Subject: ESP Meteorological Audit Response Letter cc: "James T. Davis" < JTDAVIS@southernco.com>

Docket No.: 52-011 AR-07-0059

Southern Nuclear Operating Company
Vogtle Early Site Permit Application
Safety Review Site Audit Meteorology Information Needs

Information Needs from the December 2006 Safety Review Site Audit

Figure 2.3-1 Climatological Observing Stations Near the VEGP Site

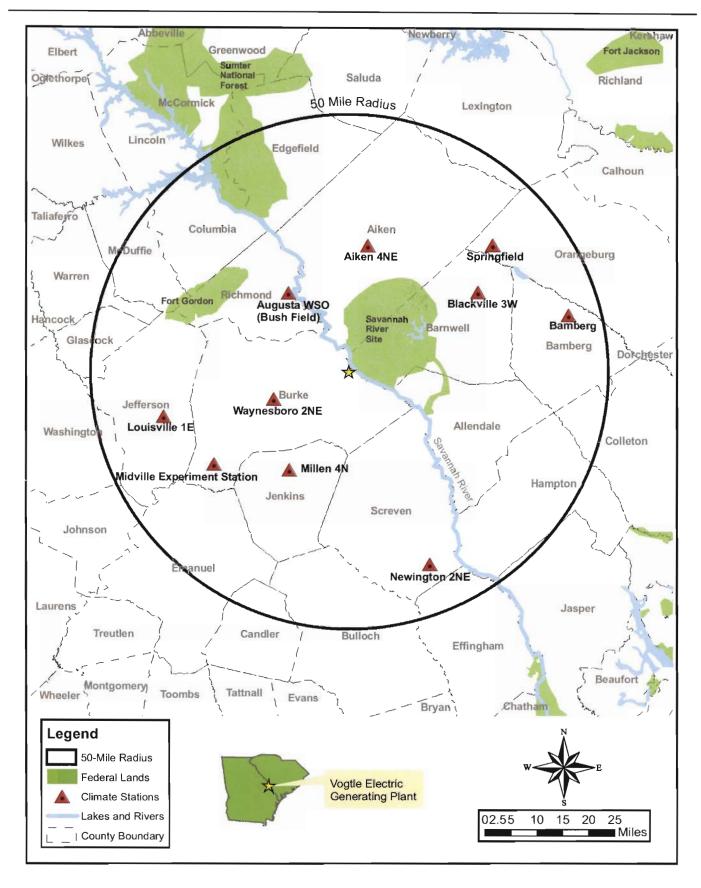
2.3.1-2 Eight climatological observing stations were used to characterize the regional climatology of the Vogtle ESP site. The staff identified a total of seventeen observing stations around (i.e. within a 50 mile radius) the Vogtle ESP site with 13 to 94 years of available data. Please explain the selection process used for the eight observation stations listed in the SSAR.

- 2.3.1-3 Using the eight observing stations identified in SSAR Section 2.3.1.1, regional climatological precipitation statistics of the site are presented in SSAR Section 2.3.1.3.4, "Precipitation Extremes" and summarized in Table 2.3.3, "Climatological Extremes at Selected NWS and Cooperative Observing Stations in the VEGP Site Area." Using climatic data from NCDC, the staff found a higher maximum monthly rainfall observation at Louisville, GA and a higher maximum 24-hr snowfall and maximum monthly snowfall observation at Bamberg, SC as compared to the values in SSAR Table 2.3.3. Please confirm that the values presented are the most extreme values for the proposed Vogtle ESP site.

- 1. The 2001 data base was revised as explained in response to Question 2.3.2-3 (2). The results were to decrease the occurrence of daytime F and G stability class. The resulting 2001 plots will now look much like the other 4 years.
- 2. This question was answered in response to Question 2.3.2-3 (1).
- 2.3.2-5 SSAR Section 2.3.2.2.3 states that "extreme maximum temperatures recorded in the vicinity of the VEGP site have ranged from 105oF to 110oF, with the highest reading observed at the Newington 2NE Station on July 13th, 1980." However, the staff found a higher extreme maximum temperature recorded in the vicinity of the VEGP site, 112oF, which occurred at Louisville 1E on July 24th, 1952.

The 50-mile radius circle shown in Figure 2.3-1 is only used to provide the reader with a relative indication of the distance between the climate observing stations and the VEGP site. A 50-km (about 31-mile) grid spacing is considered to be a reasonably fine mesh grid in current regional climate modeling and this distance was used as a nominal radius for the station selection process.

Also, upon further evaluation of the Bamberg Station record, this station will be added to Table 2.3-3 and Figure 2.3-1, despite its distance from the VEGP site (i.e., about 43.5 miles, or 70 km), because it contributes both the highest of the maximum daily and maximum monthly snowfall totals in the site area.

In evaluating the Louisville 1E station temperature records, SNC agrees with the reported overall maximum temperature value of 112°F. This station will be added to Table 2.3-3 and Figure 2.3-1 because it contributes the highest of the maximum daily temperature records in the site area despite its distance from the VEGP site (i.e., about 37 miles or 60 kilometers) exceeding the selection criteria discussed in response to Question 2.3.1-2.
